MEMO

DATE: July 21, 2015
TO: Adam Tartakovsky, 10 SVN, LLC
FROM: Lisa Gibson, Planning Department
RE: PPA Case No. 2015-004568PPA for 10 South Van Ness Avenue

Preliminary Project Assessment

Date: July 21, 2015
Case No.: **2015-004568PPA**
Project Address: 10 South Van Ness Avenue
Block/Lot: 3506/004, 003A
Zoning: C-3-G (Downtown-General) District
Van Ness & Market Downtown Residential SUD
120-R-2 and 120/400-R-2 Height and Bulk District
Area Plan: Market and Octavia Area Plan
Project Sponsor: Adam Tartakovsky, Crescent Heights – (415) 527-9742
atartakovsky@crescentheights.com
Staff Contact: Melinda Hue – (415) 575-9041
Melinda.Hue@sfgov.org

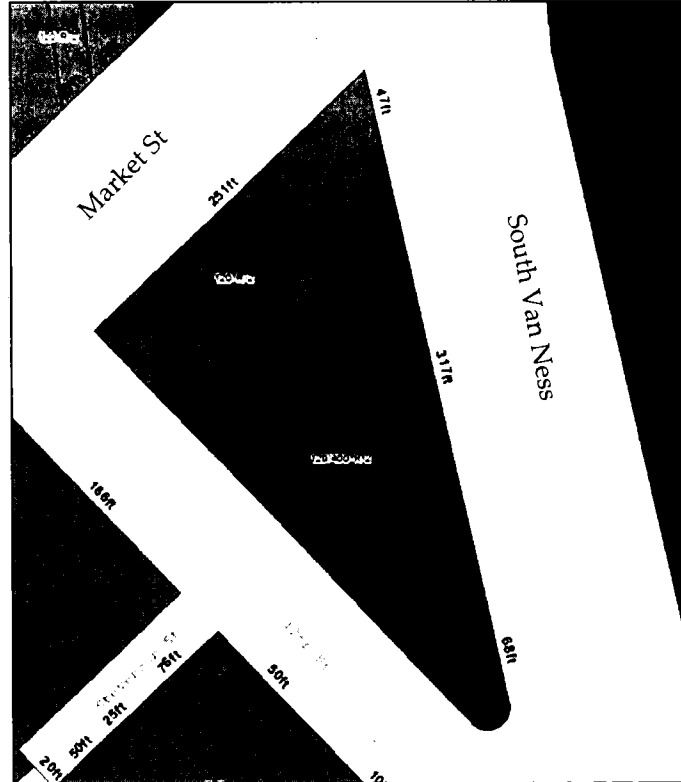
2. **Height.** Multiple Height and Bulk Districts apply to the project site. The northern portion of site is zoned 120-R-2 (with a 120' height limit), and the southern portion of the site is zoned 120-400-R-2 (120' podium height, with a tower of up to 400' in height). Portions of the northern tower are located within the 120-R-2 District, and exceed the allowable height for this District. The boundaries for the 120-R-2 District on the subject block are shown below:

In addition, the sloping parapets of both towers reach a maximum height of 440 feet, exceeding the allowances for features above the roof height limit described in Section 260(b). The project would need to be redesigned to comply with the applicable height limits, or the project sponsor would need to pursue Legislative Amendments (Height Reclassification and General Plan Amendments) in order to proceed as proposed. It should also be noted that the project does not comply with the tower separation requirements applicable to the 120-400-R-2 Height and Bulk District, as discussed below.
